Agar Grove Phase 1c

Non-material Amendment Application 2024 AGV-HBA-ZZ-XX-RP-A-080010

The current non-material amendment proposal regards non-material changes to Block H, I and JKL as listed below:

Change (1) - Block I - Courtyard gardens

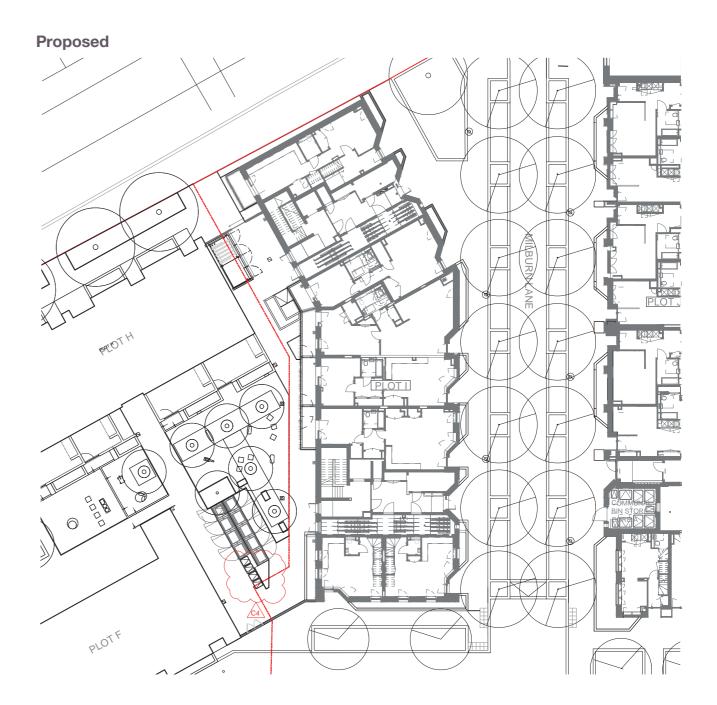
Amendment to rear garden design:

Amendment: Metal privacy panels (RAL 7039 matching window sash) added to railing & gate positioning amended and ramp added to top garden.

Reasoning: To provide privacy to residents from the courtyard & to provide level access thresholds to gardens and comply with Approved Document M. Panels also screen off the private garden areas, concealing objects in the gardens from the wider estate, providing a improved aesthetic appearance and reducing theft risk.

Change (2) - Block H - Cycle Storage

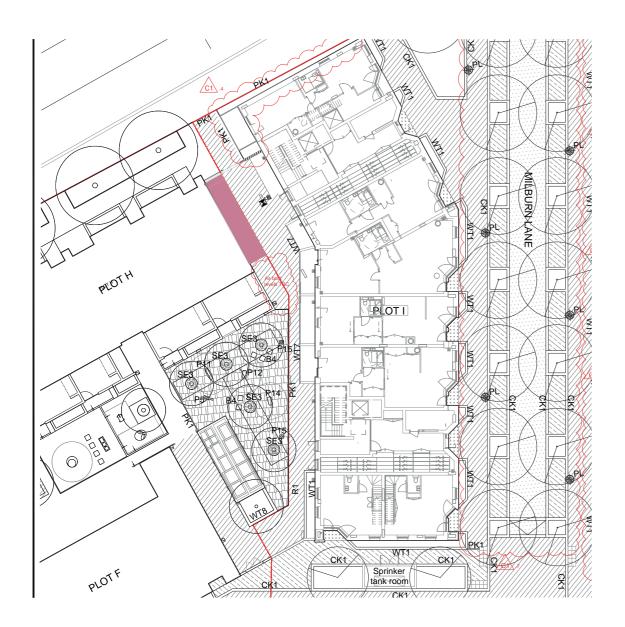
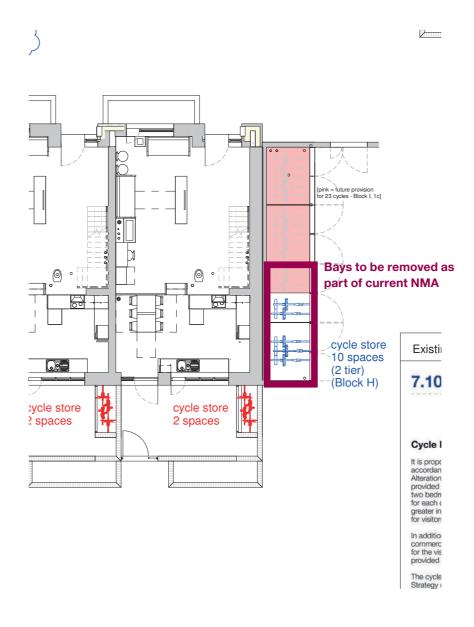
Proposal: to remove two bays (14 bikes) of the external Block H cycle storage

Removal of the two bays out of four highlighted adjacent on extract from drawing T14011-ART-DR-A-1bH-GA-066 removes the Block I over provision and leaves the 10 spaces for Block H and a single space for Block I.

The reduction of the cycle store provides additional circulation space needed for the ramp providing disabled access for the raised garden area.

The reduced bike store opens up a previous pinch point in the landscape plan and provides a more generous area.
